MONITORING YEAR 1 ANNUAL REPORT

SHAKE RAG MITIGATION SITE

RE: Shake Rag Mitigation Site – Monitoring Year 1 Report Response to DMS Comments
French Broad River Basin – CU# 06010105 – Madison County
DMS Project ID No. 100018
Contract # 7190

Madison County, NC

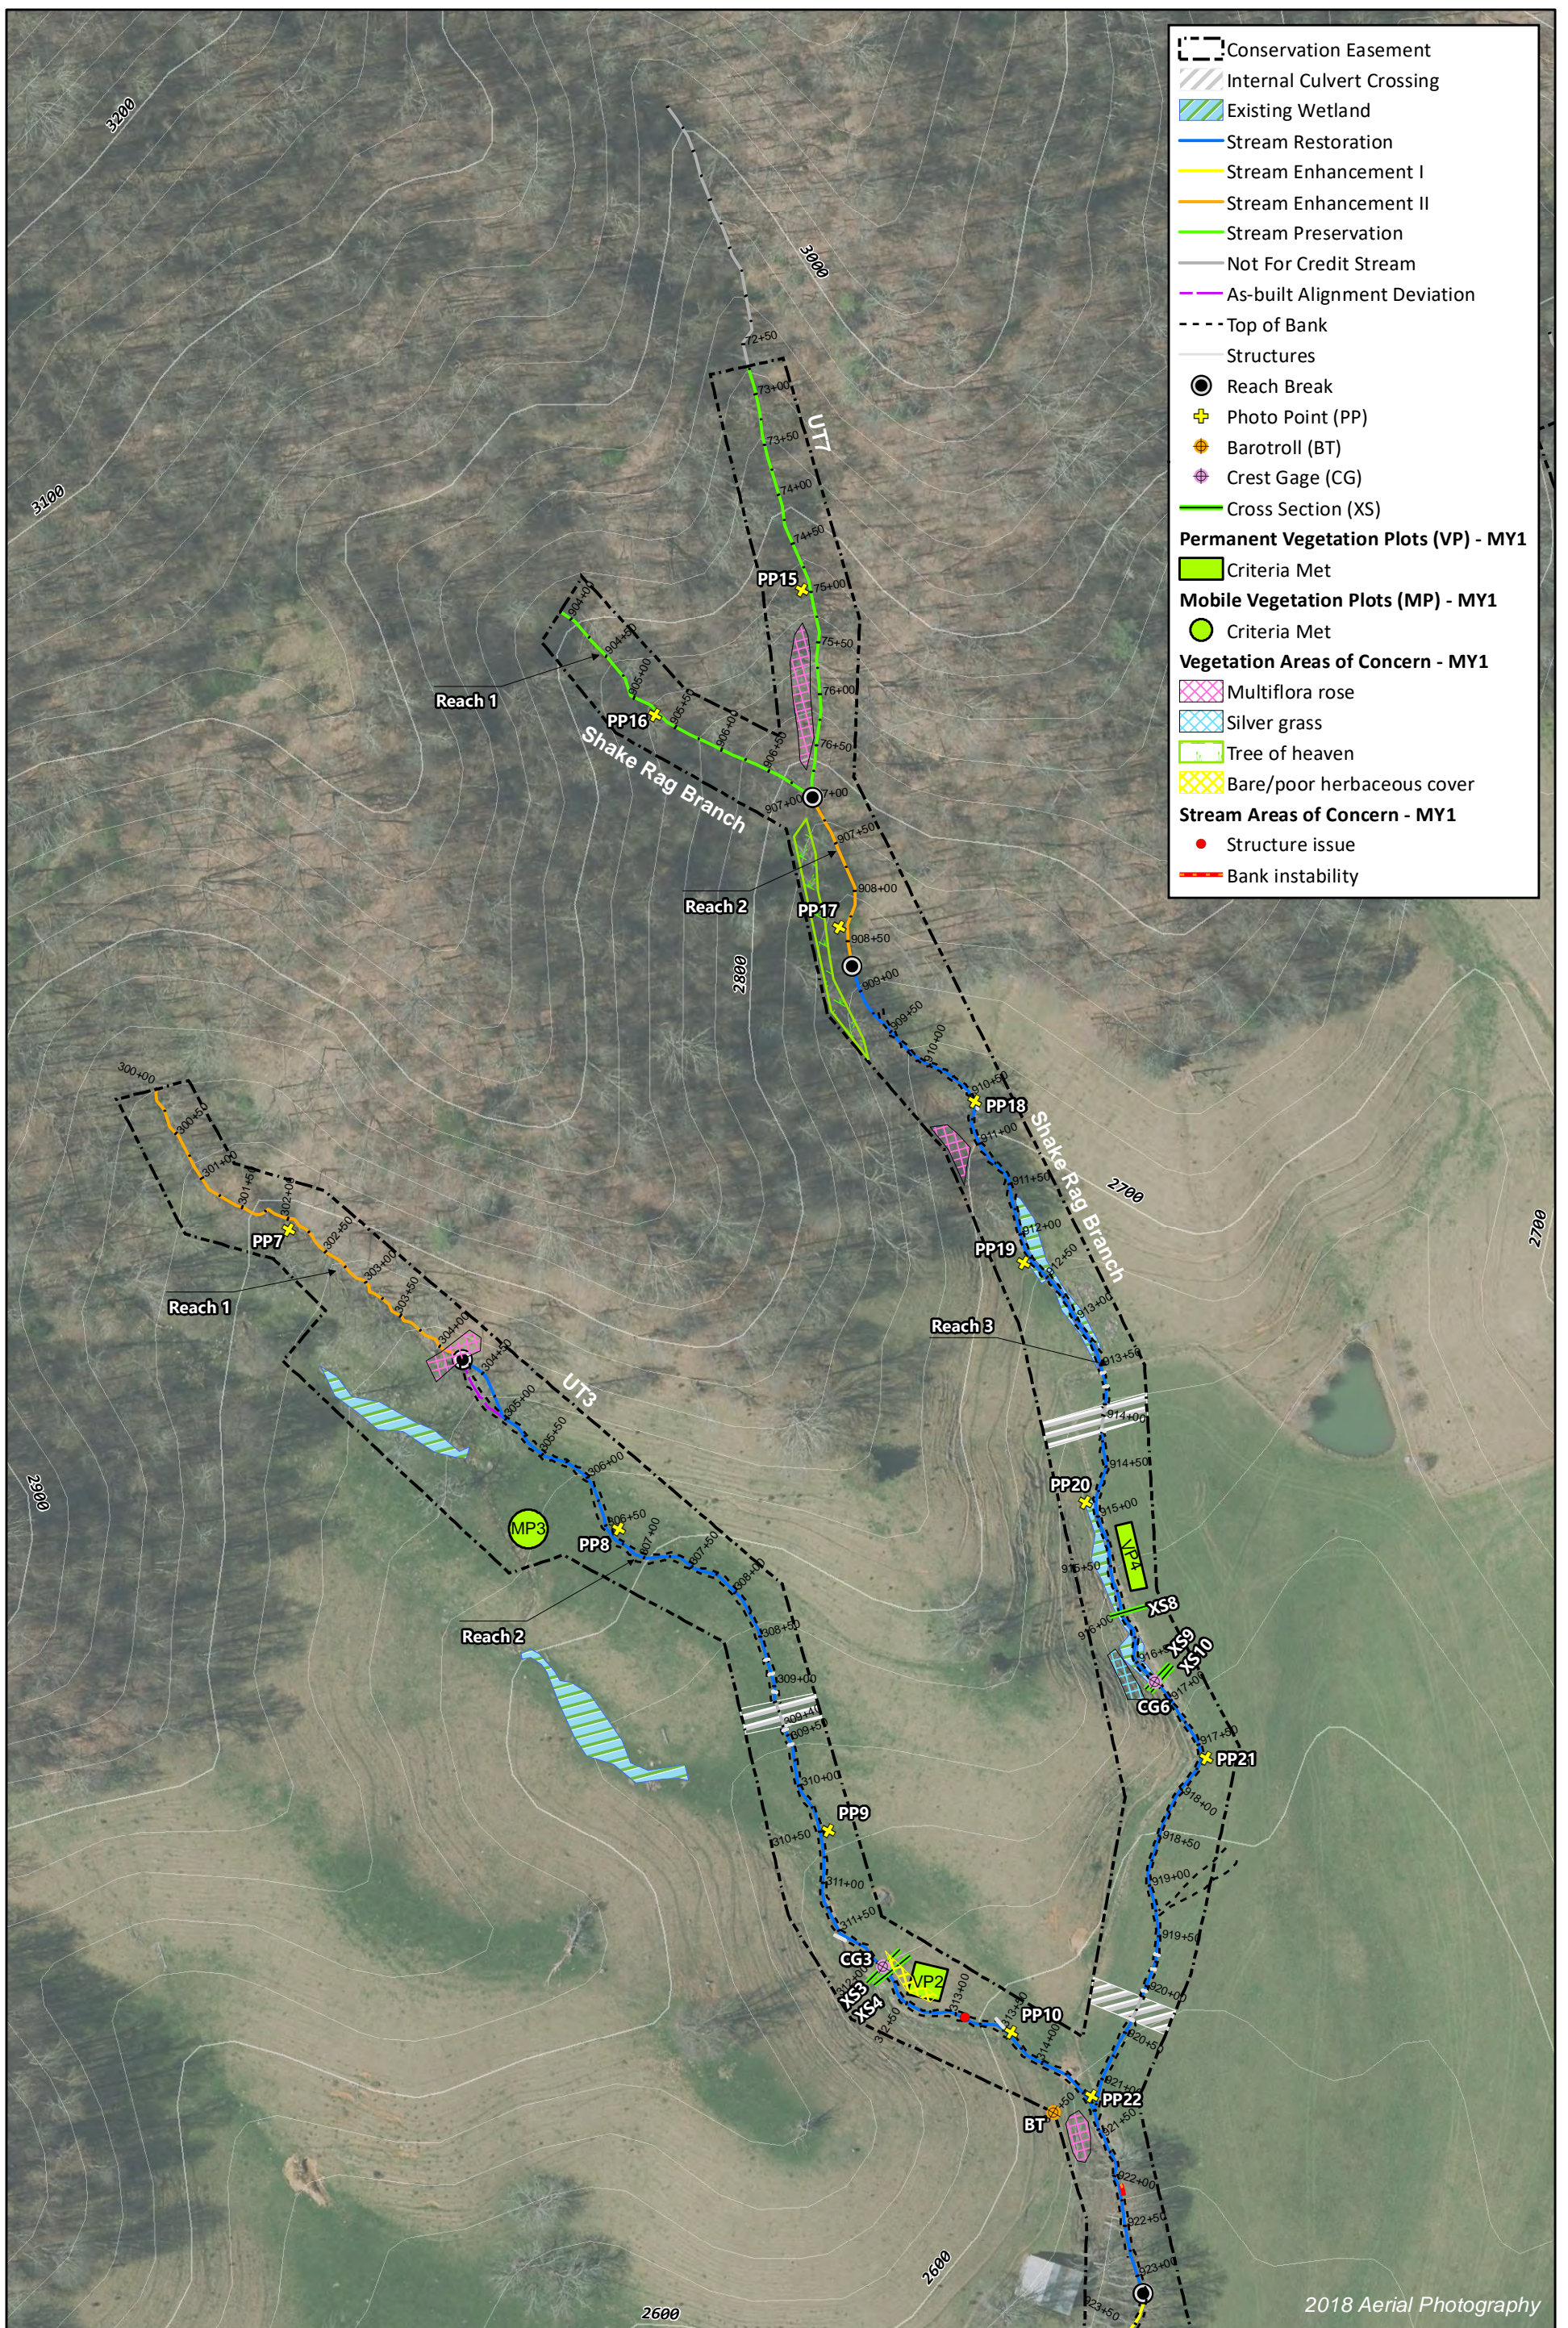
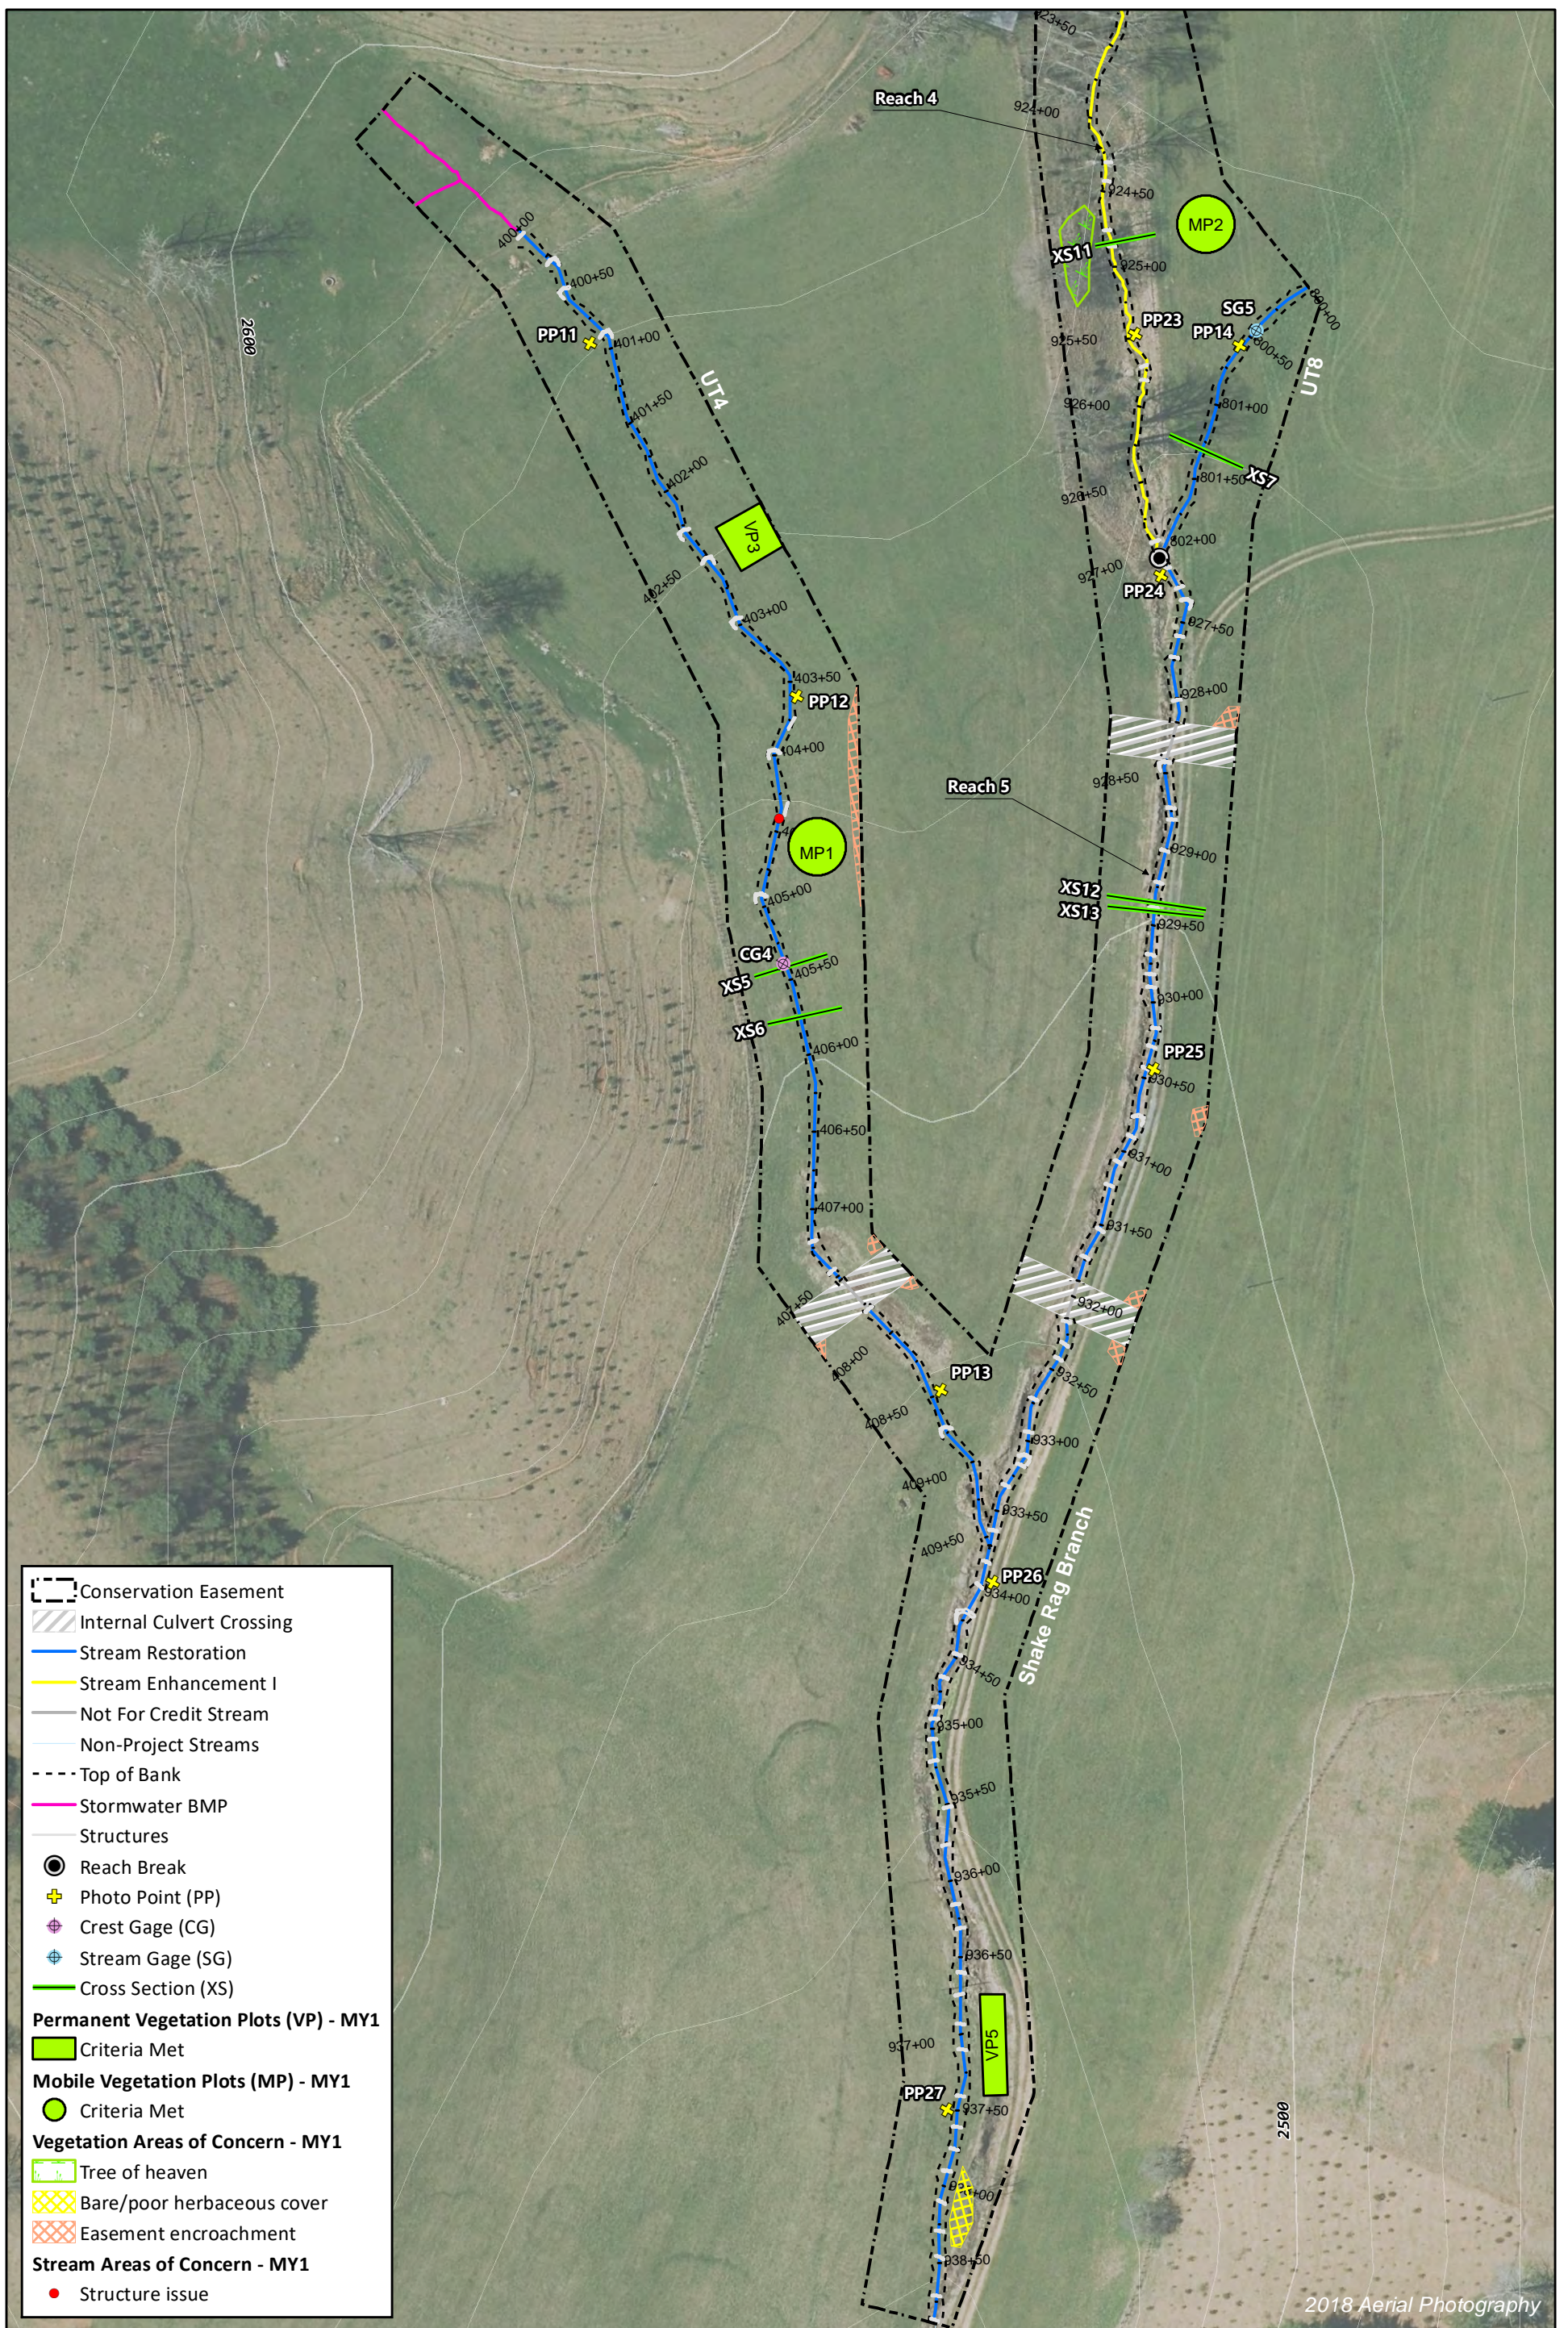
DMS comment: CCPV: The report (section 1.2.5) indicates that the areas of concern noted on the CCPV were repaired in November. If this is the case, please update the CCPV Legend to “Structure Issue – Repaired Nov. 2020” or something similar. It appears to the reviewer that these are current and ongoing problems. If there are known problem areas that developed after the repair or remain on-site, please mark those with a different symbol.

DMS comment: Tables 6b, 6c and 6d: These tables should represent what is currently on the ground and match what is shown on the CCPV. Are the numbers shown in the “Engineered Structures” category calculated using what was repaired or are these different problem areas? Please update as necessary along with CCPV.

Wildlands response: Since these areas of concern were repaired and no longer of issue, they were removed from the CCPV maps and associated stability tables.

Wildlands response: Tables 6b, 6c, and 6d have been updated to represent what is currently a known stream stability issue. As stated above, all repaired areas have been removed from the CCPV maps, and only current issues remain.
